MALABAR

MAXWELL UNDERGROUND MINE

HERITAGE MANAGEMENT PLAN

Figure 7. Longwall Panels 1- 4 arrangement

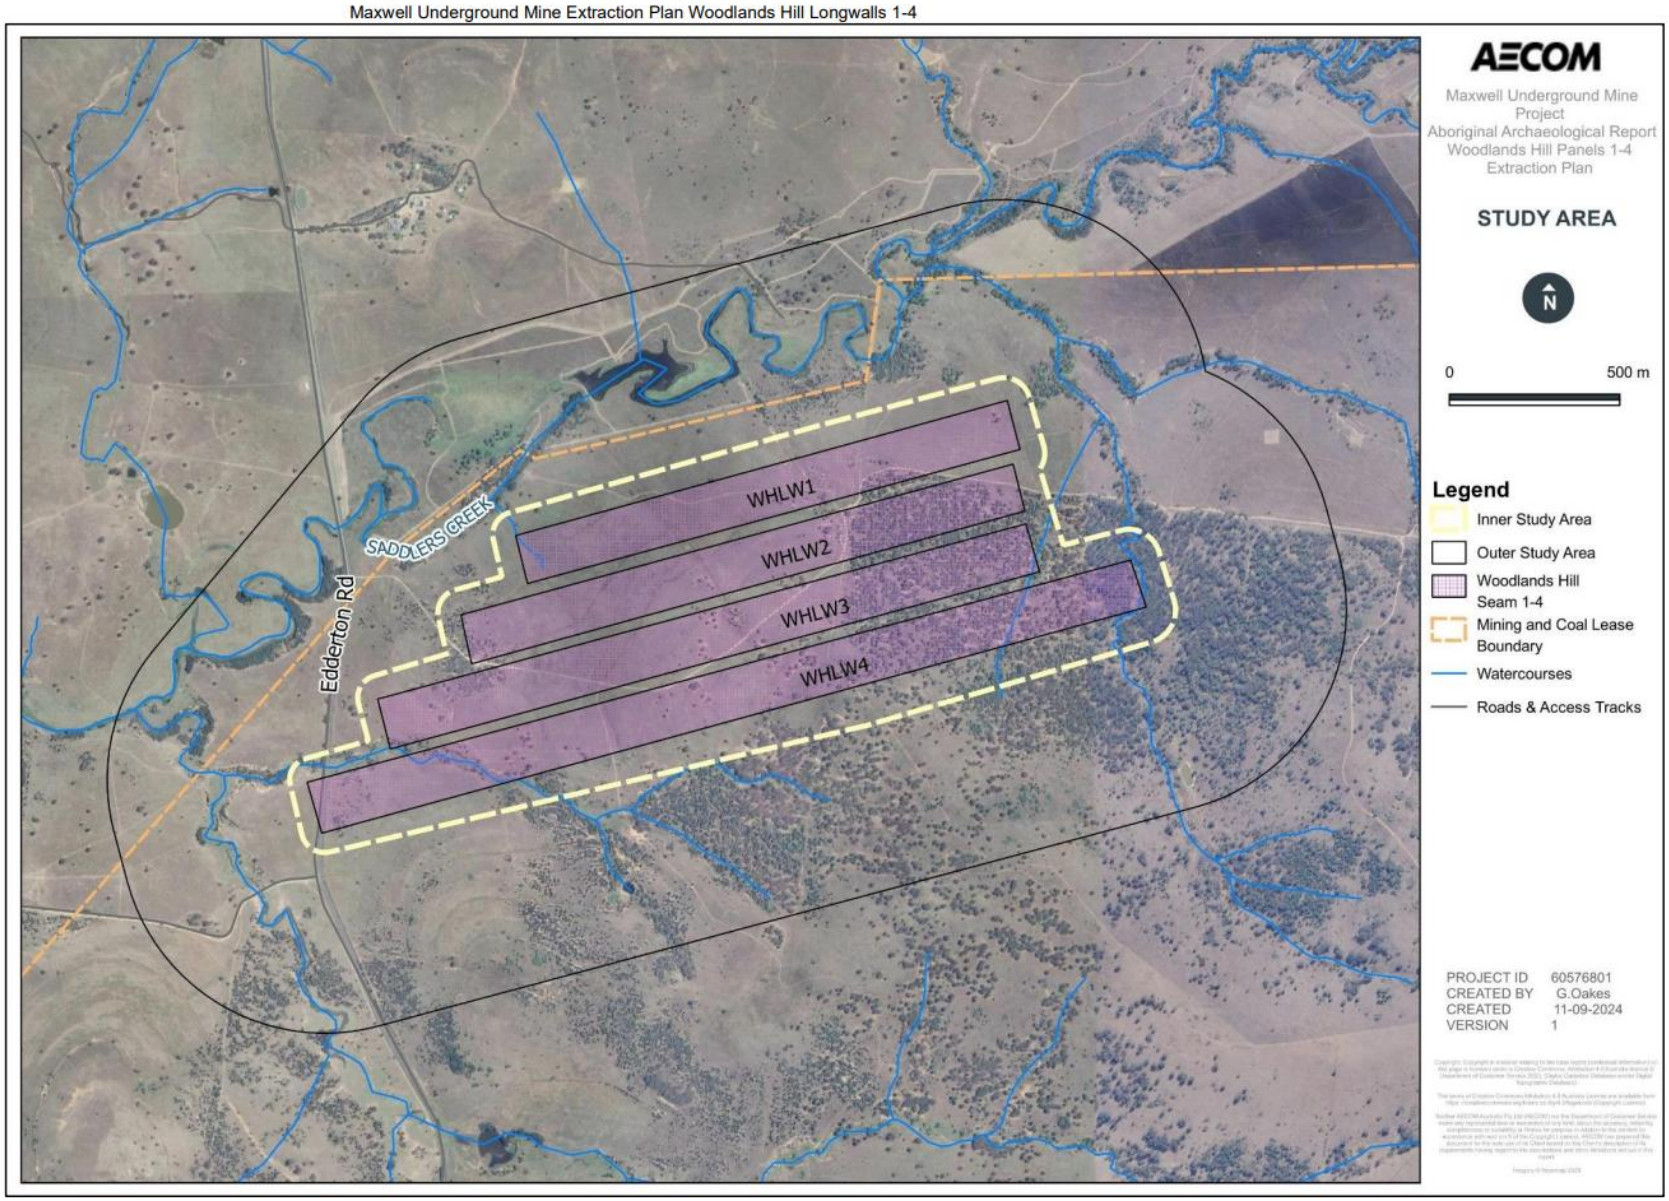
4. Please include a figure of the proposed longwalls, the angle of draw, and any buffer for far field horizontal impacts in the HMP.	An additional figure (Figure 7.) has been included to represent these areas.
